RE: U.S. Patent Application Serial No. 09/889,759
Our ref: WOLFRAMM ET AL-1

APPLICANT: ARIBERT WOLFRAMM ET AL.-1 EXAMINER: S. BUCZINSKI
SERIAL NO.: 09/889,759 GROUP: 3662
FILED: JULY 20, 2001 CONFIRMATION NO. 1045
FOR: METHOD FOR INTERFEROMETRIC RADAR MEASUREMENT

AMENDMENT IN RESPONSE TO THE FIRST OFFICE ACTION

Fig. 2

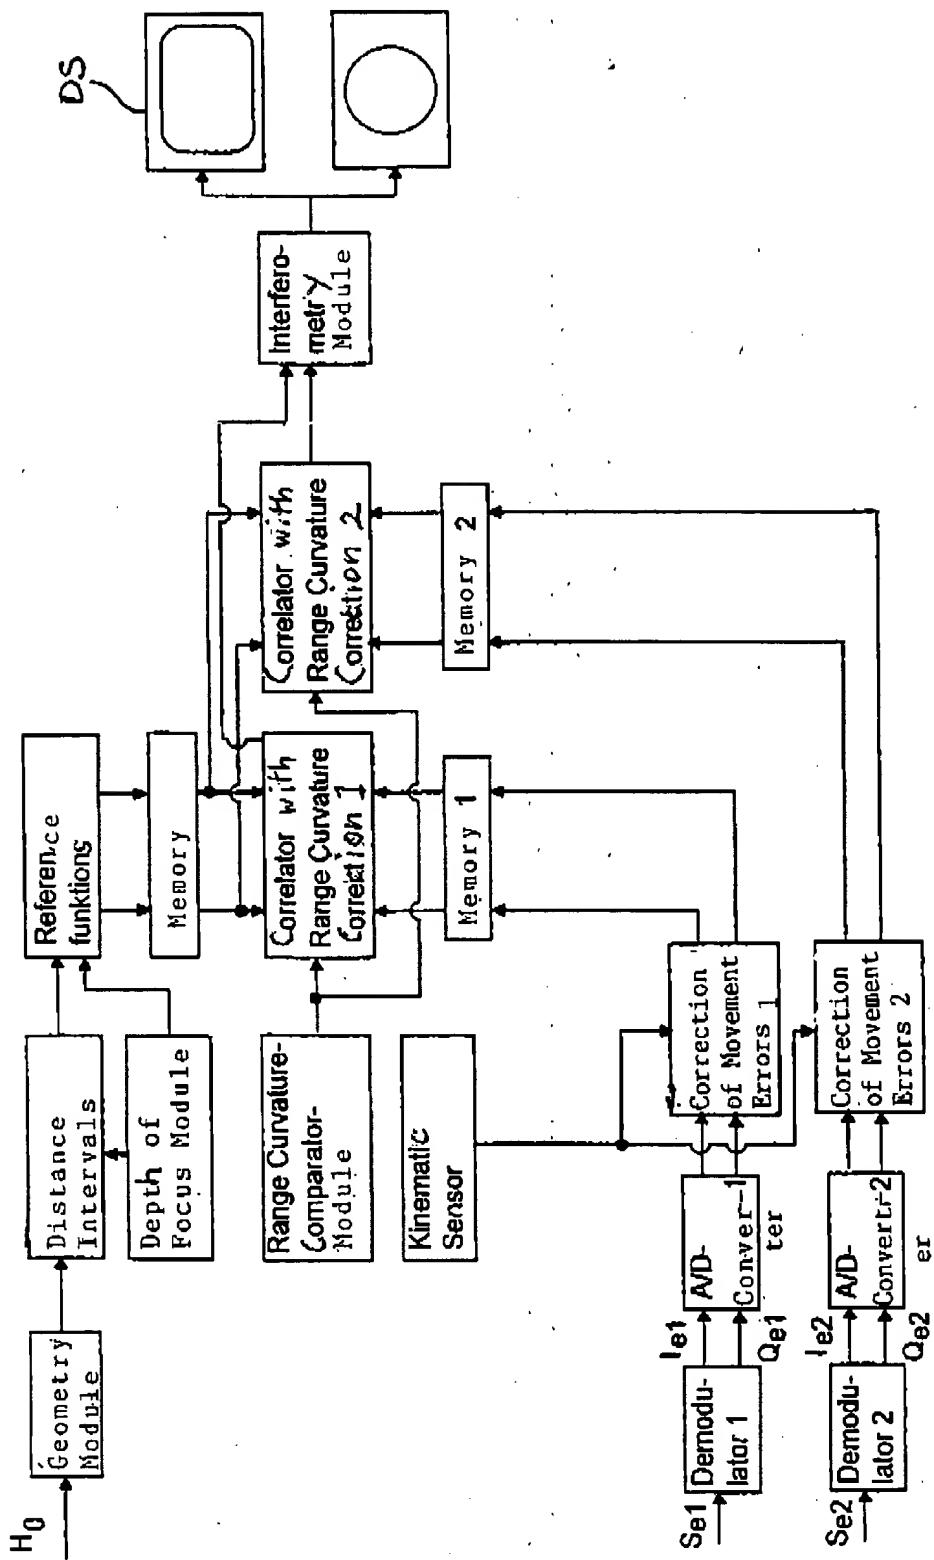
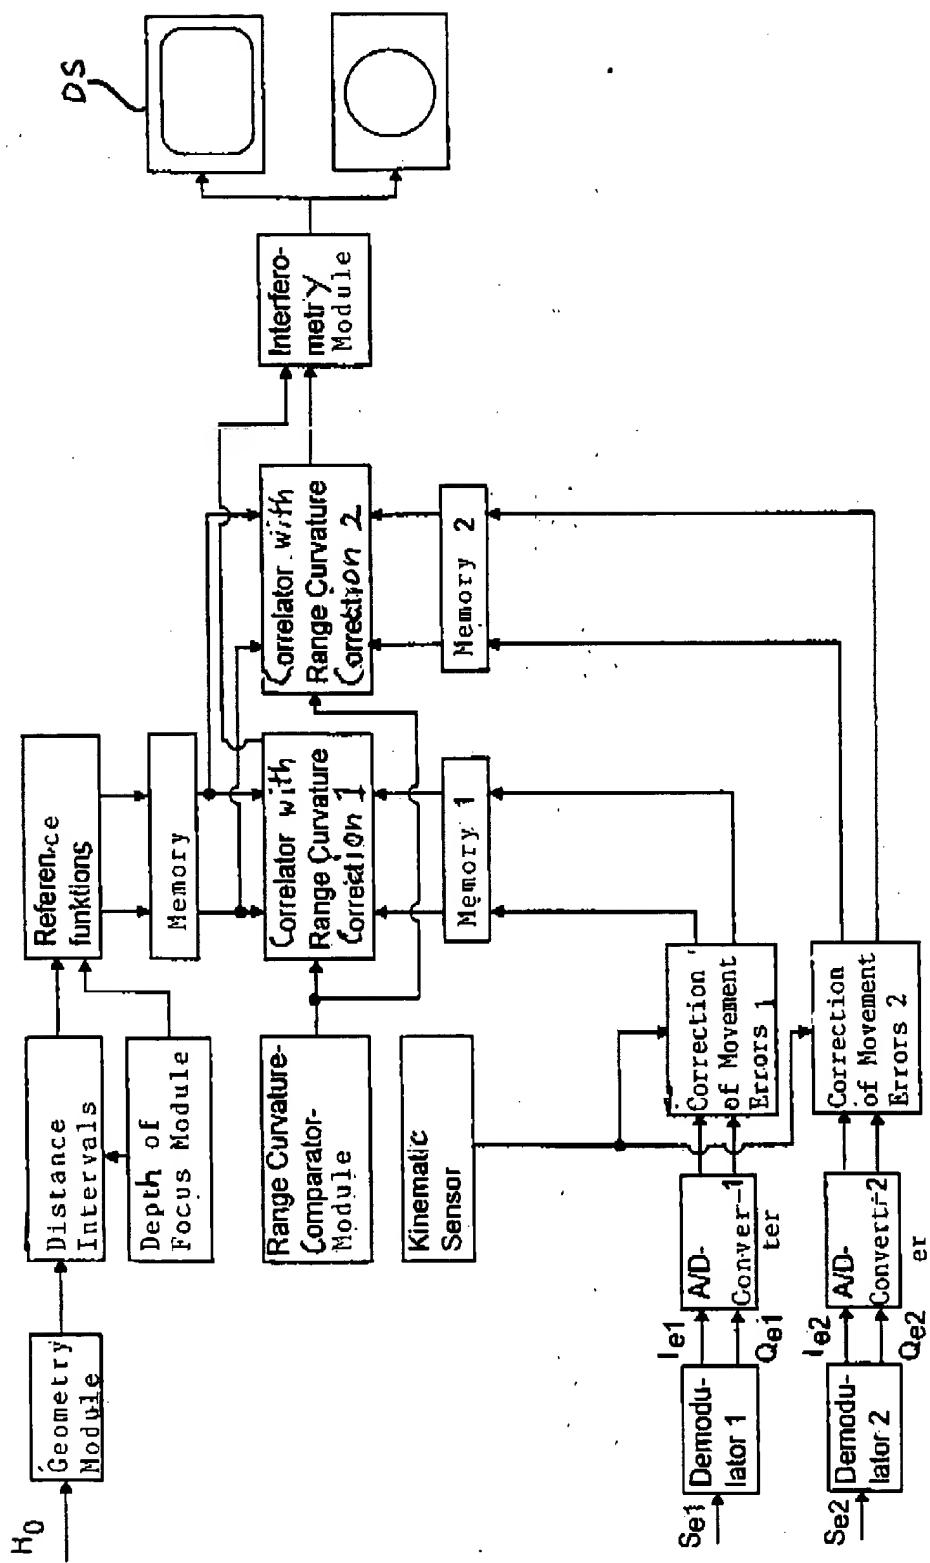
FIG. 2 has been amended. A marked-up copy and a substitute copy of FIG. 2 are enclosed (Attachment A).

The Examiner has objected to the drawings. FIG. 2 has been amended to clearly label the display screen. Further, image points on a graphics display screen are commonly known to those in the field, and the applicant believes that they have been adequately shown in the drawing. Additionally, the image points on a graphics display screen are included in a dependent method claim and are not an element of the apparatus being claimed.
